# **Technical Service Information**

### 4T40E/4T45E **CODE P1810**

**COMPLAINT:** After transmission exchange or valve body replacement, a code P1810 for the Transmission

Figure 1
AUTOMATIC TRANSMISSION SERVICE GROUP

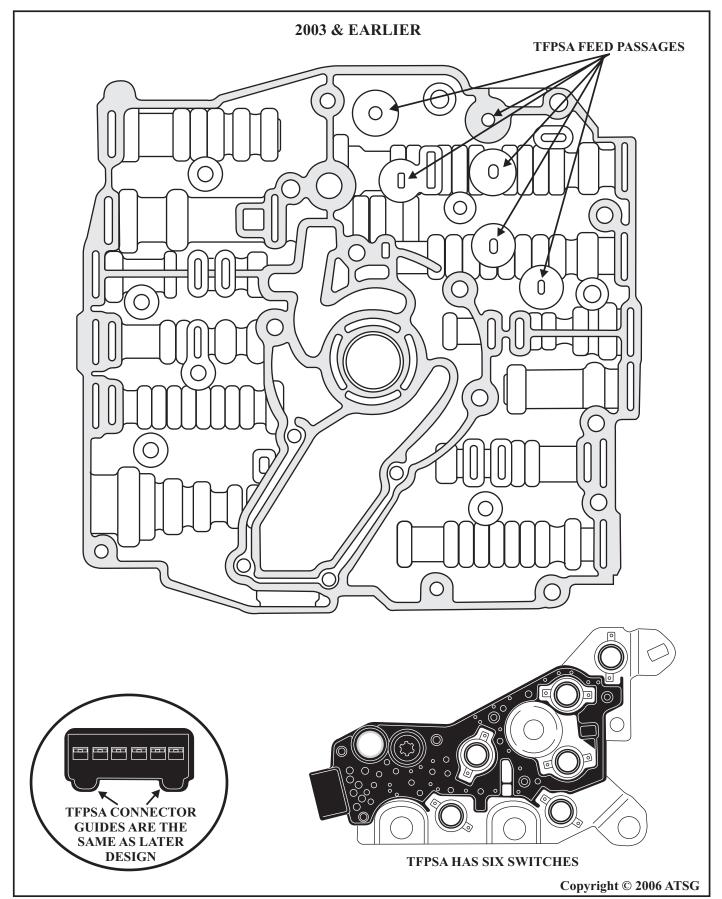
**CORRECTION:** The first design 4T40E transmission or valve body utilized a six (6) switch Transmission Fluid Pressure Switch assembly as seen in Figure 1. The valve body has six (6) feed passages to activate the various pressure switches in the switch assembly, also seen in Figure 1. At the start of 2004 production a newly designed Transmission Fluid Pressure Switch Assembly was used which only has three (3) pressure switches as seen in Figure 2. At the same time the pressure switch feed passages in the valve body that were no longer needed were cast shut also seen in Figure 2.

> In addition, the pressure switch assembly connector cavity is the same for both the early and the late design which can be seen in Figures 1 and 2 when compared. This means the early and late assemblies will easily connect.

Figure 2

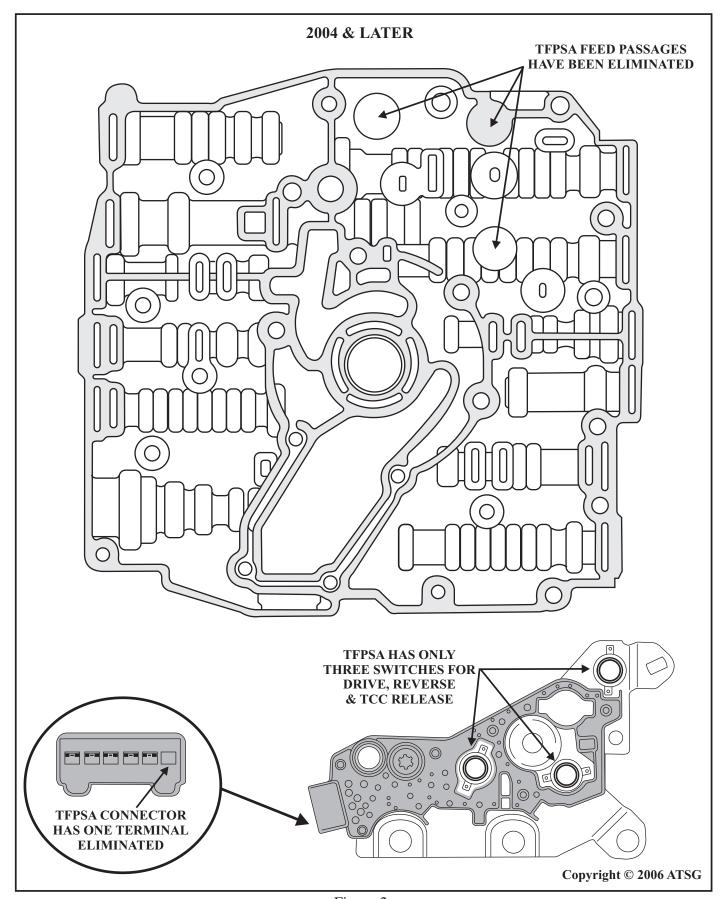
> When a late transmission was installed into an earlier vehicle, upon ignition cycle, the TFPSA had an open circuit due to one less terminal and wire, thereby immediately storing the P1810 code.
